Village of Arlington Heights
Plan Commission
Board Room
Arlington Heights Village Hall
33 S. Arlington Heights Road
Arlington Heights, IL 60005
January 25, 2017
7:30 PM

- A. Southpoint Shopping Center - 630-720 E. Rand Rd. - PC#16-025
Preliminary and Final Plat of Resubdivision
- B. Windsor School - 1315 E. Miner St. - PC#16-026
Amendment to Special Use Ordinance #90-082

File Number: PC #16-026
Project Title: Windsor Elementary School Addition
Address: 1315 East Miner Street
PIN: 03-29-412-015 thru -016, 03-29-412-042

Sheet No:
C2.1

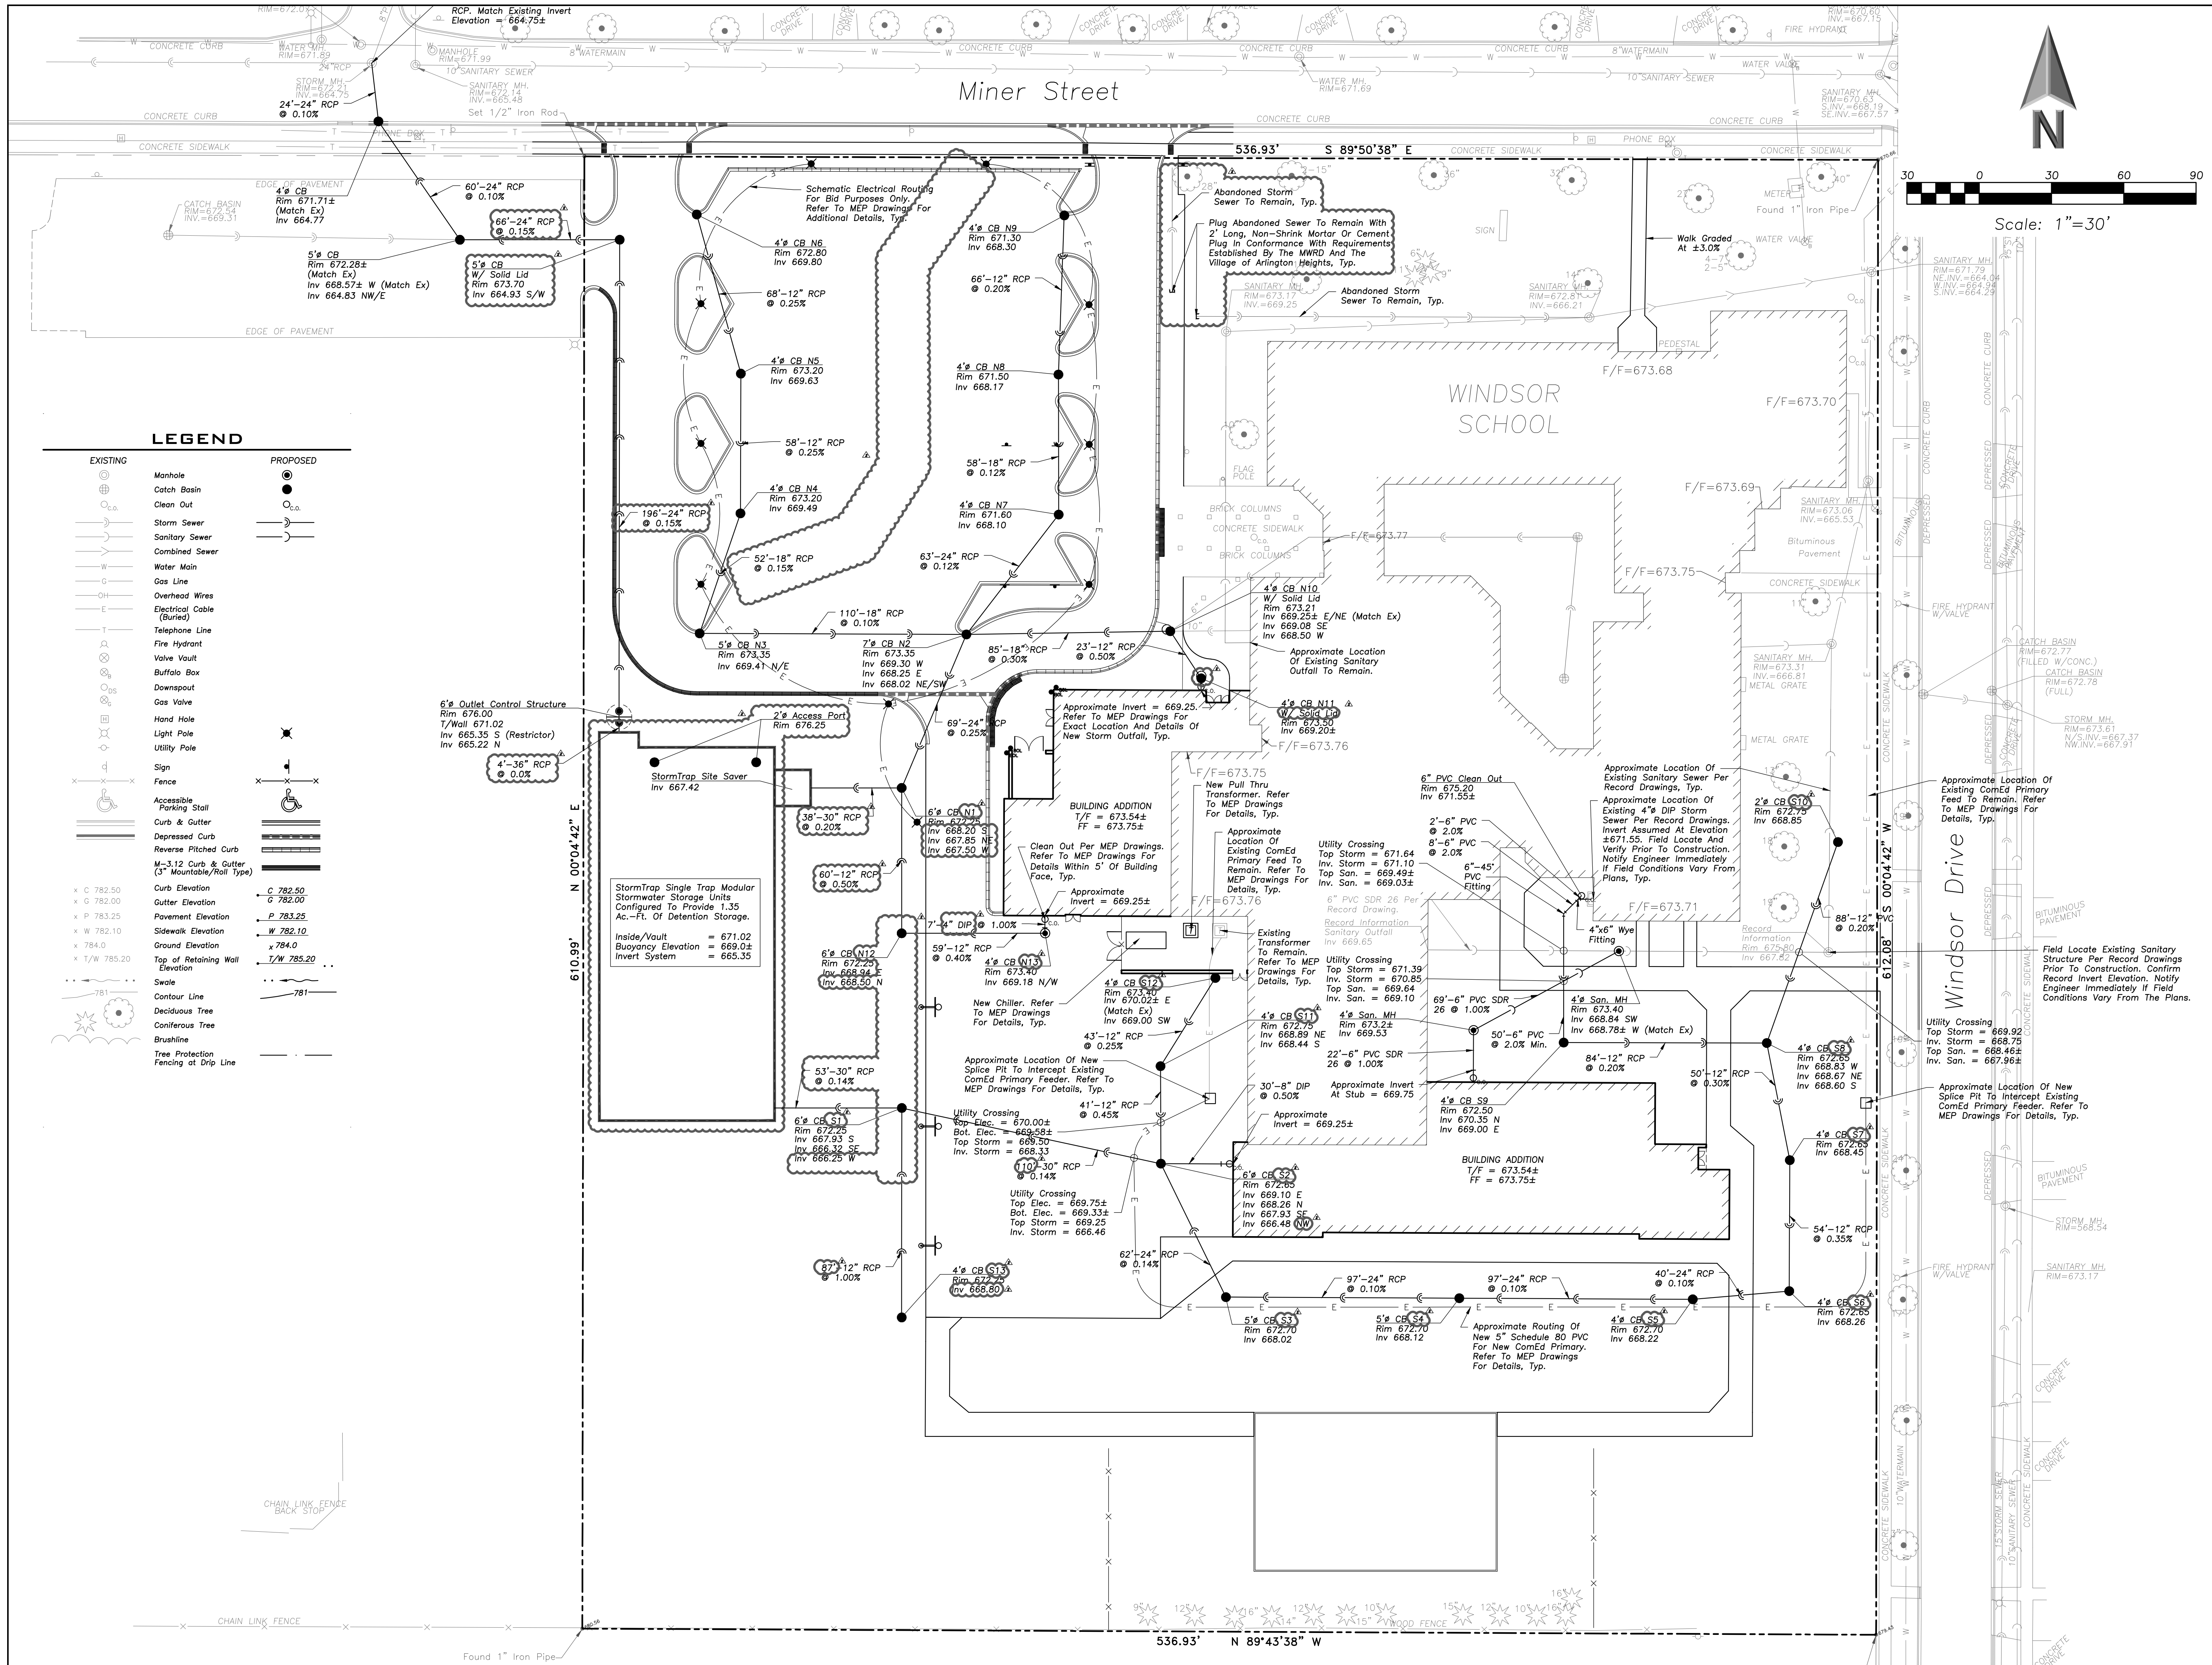
14. Please revise sheet C2.1 of the engineering plans to show the proposed setbacks of the building addition to the property lines.
15. Was the rubber surface play area considered as impervious surface and included within the impervious surface calculation?

24. In counting the total number of parking spaces as shown on sheet C2.1 of the engineering plans, it appears that only 90 parking spaces have been proposed, however, all documents submitted indicate that 92 parking spaces are proposed. Please clarify the total number of parking spaces proposed. One of the labels which totals the number of parking spaces in a parking row indicates 12 parking spaces and 1 handicap space will be provided, however, the row actually contains 10 parking spaces and 2 handicap spaces. Please revise this sheet to reflect the correct number of parking spaces. Additionally, the Traffic and Parking Study states that 92 spaces will be provided on the site; please revise this study to reflect that only 90 spaces will be added. Finally, please revise the Written Justification for Variation approval to reflect the correct number of parking spaces that will be included on the site.

25. Please revise sheet C2.1 to include “Do Not Enter” signage facing Miner Street at the “exit only” drive aisle where the drive aisle connects to Miner Street.

14. Please revise sheet C2.1 of the engineering plans to show the proposed setbacks of the building addition to the property lines.

24. In counting the total number of parking spaces as shown on sheet C2.1 of the engineering plans, it appears that only 90 parking spaces have been proposed, however, all documents submitted indicated that 92 parking spaces are proposed. Please clarify the total number of parking spaces proposed. One of the labels which total the number of parking spaces in a parking row indicates 12 parking spaces and 1 handicap will be provided, however, the row actually contains 10 parking spaces and 2 handicap spaces. Please revise this sheet to reflect the correct number of parking spaces. Additionally, the Traffic and Parking Study states that 92 spaces will be provided on the site; please revise this study to reflect that only 90 spaces will be added. Finally, please revise the Written Justification for Variation approval to reflect the correct number of parking spaces that will be included on the site.

25. Please revise sheet C2.1 to include "Do Not Enter" signage facing Miner Street at the "exit only" drive aisle where the drive aisle connects to Miner Street.

30. The responses to comments #7-#13, #15-#26, and #29 are acceptable.
31. The response to comment #14 is noted but does not address the comment. To reiterate, the comment asked to show on sheet C2.1 **the proposed setback of the building addition to the property lines**. The revision to the plans only showed the required building setbacks. In other words, please indicate how far the southern classroom addition will be located from the east and south property lines, and how far the gym addition will be located from the north and west property lines.

The proposed building setbacks have been added to Sheet C2.1.
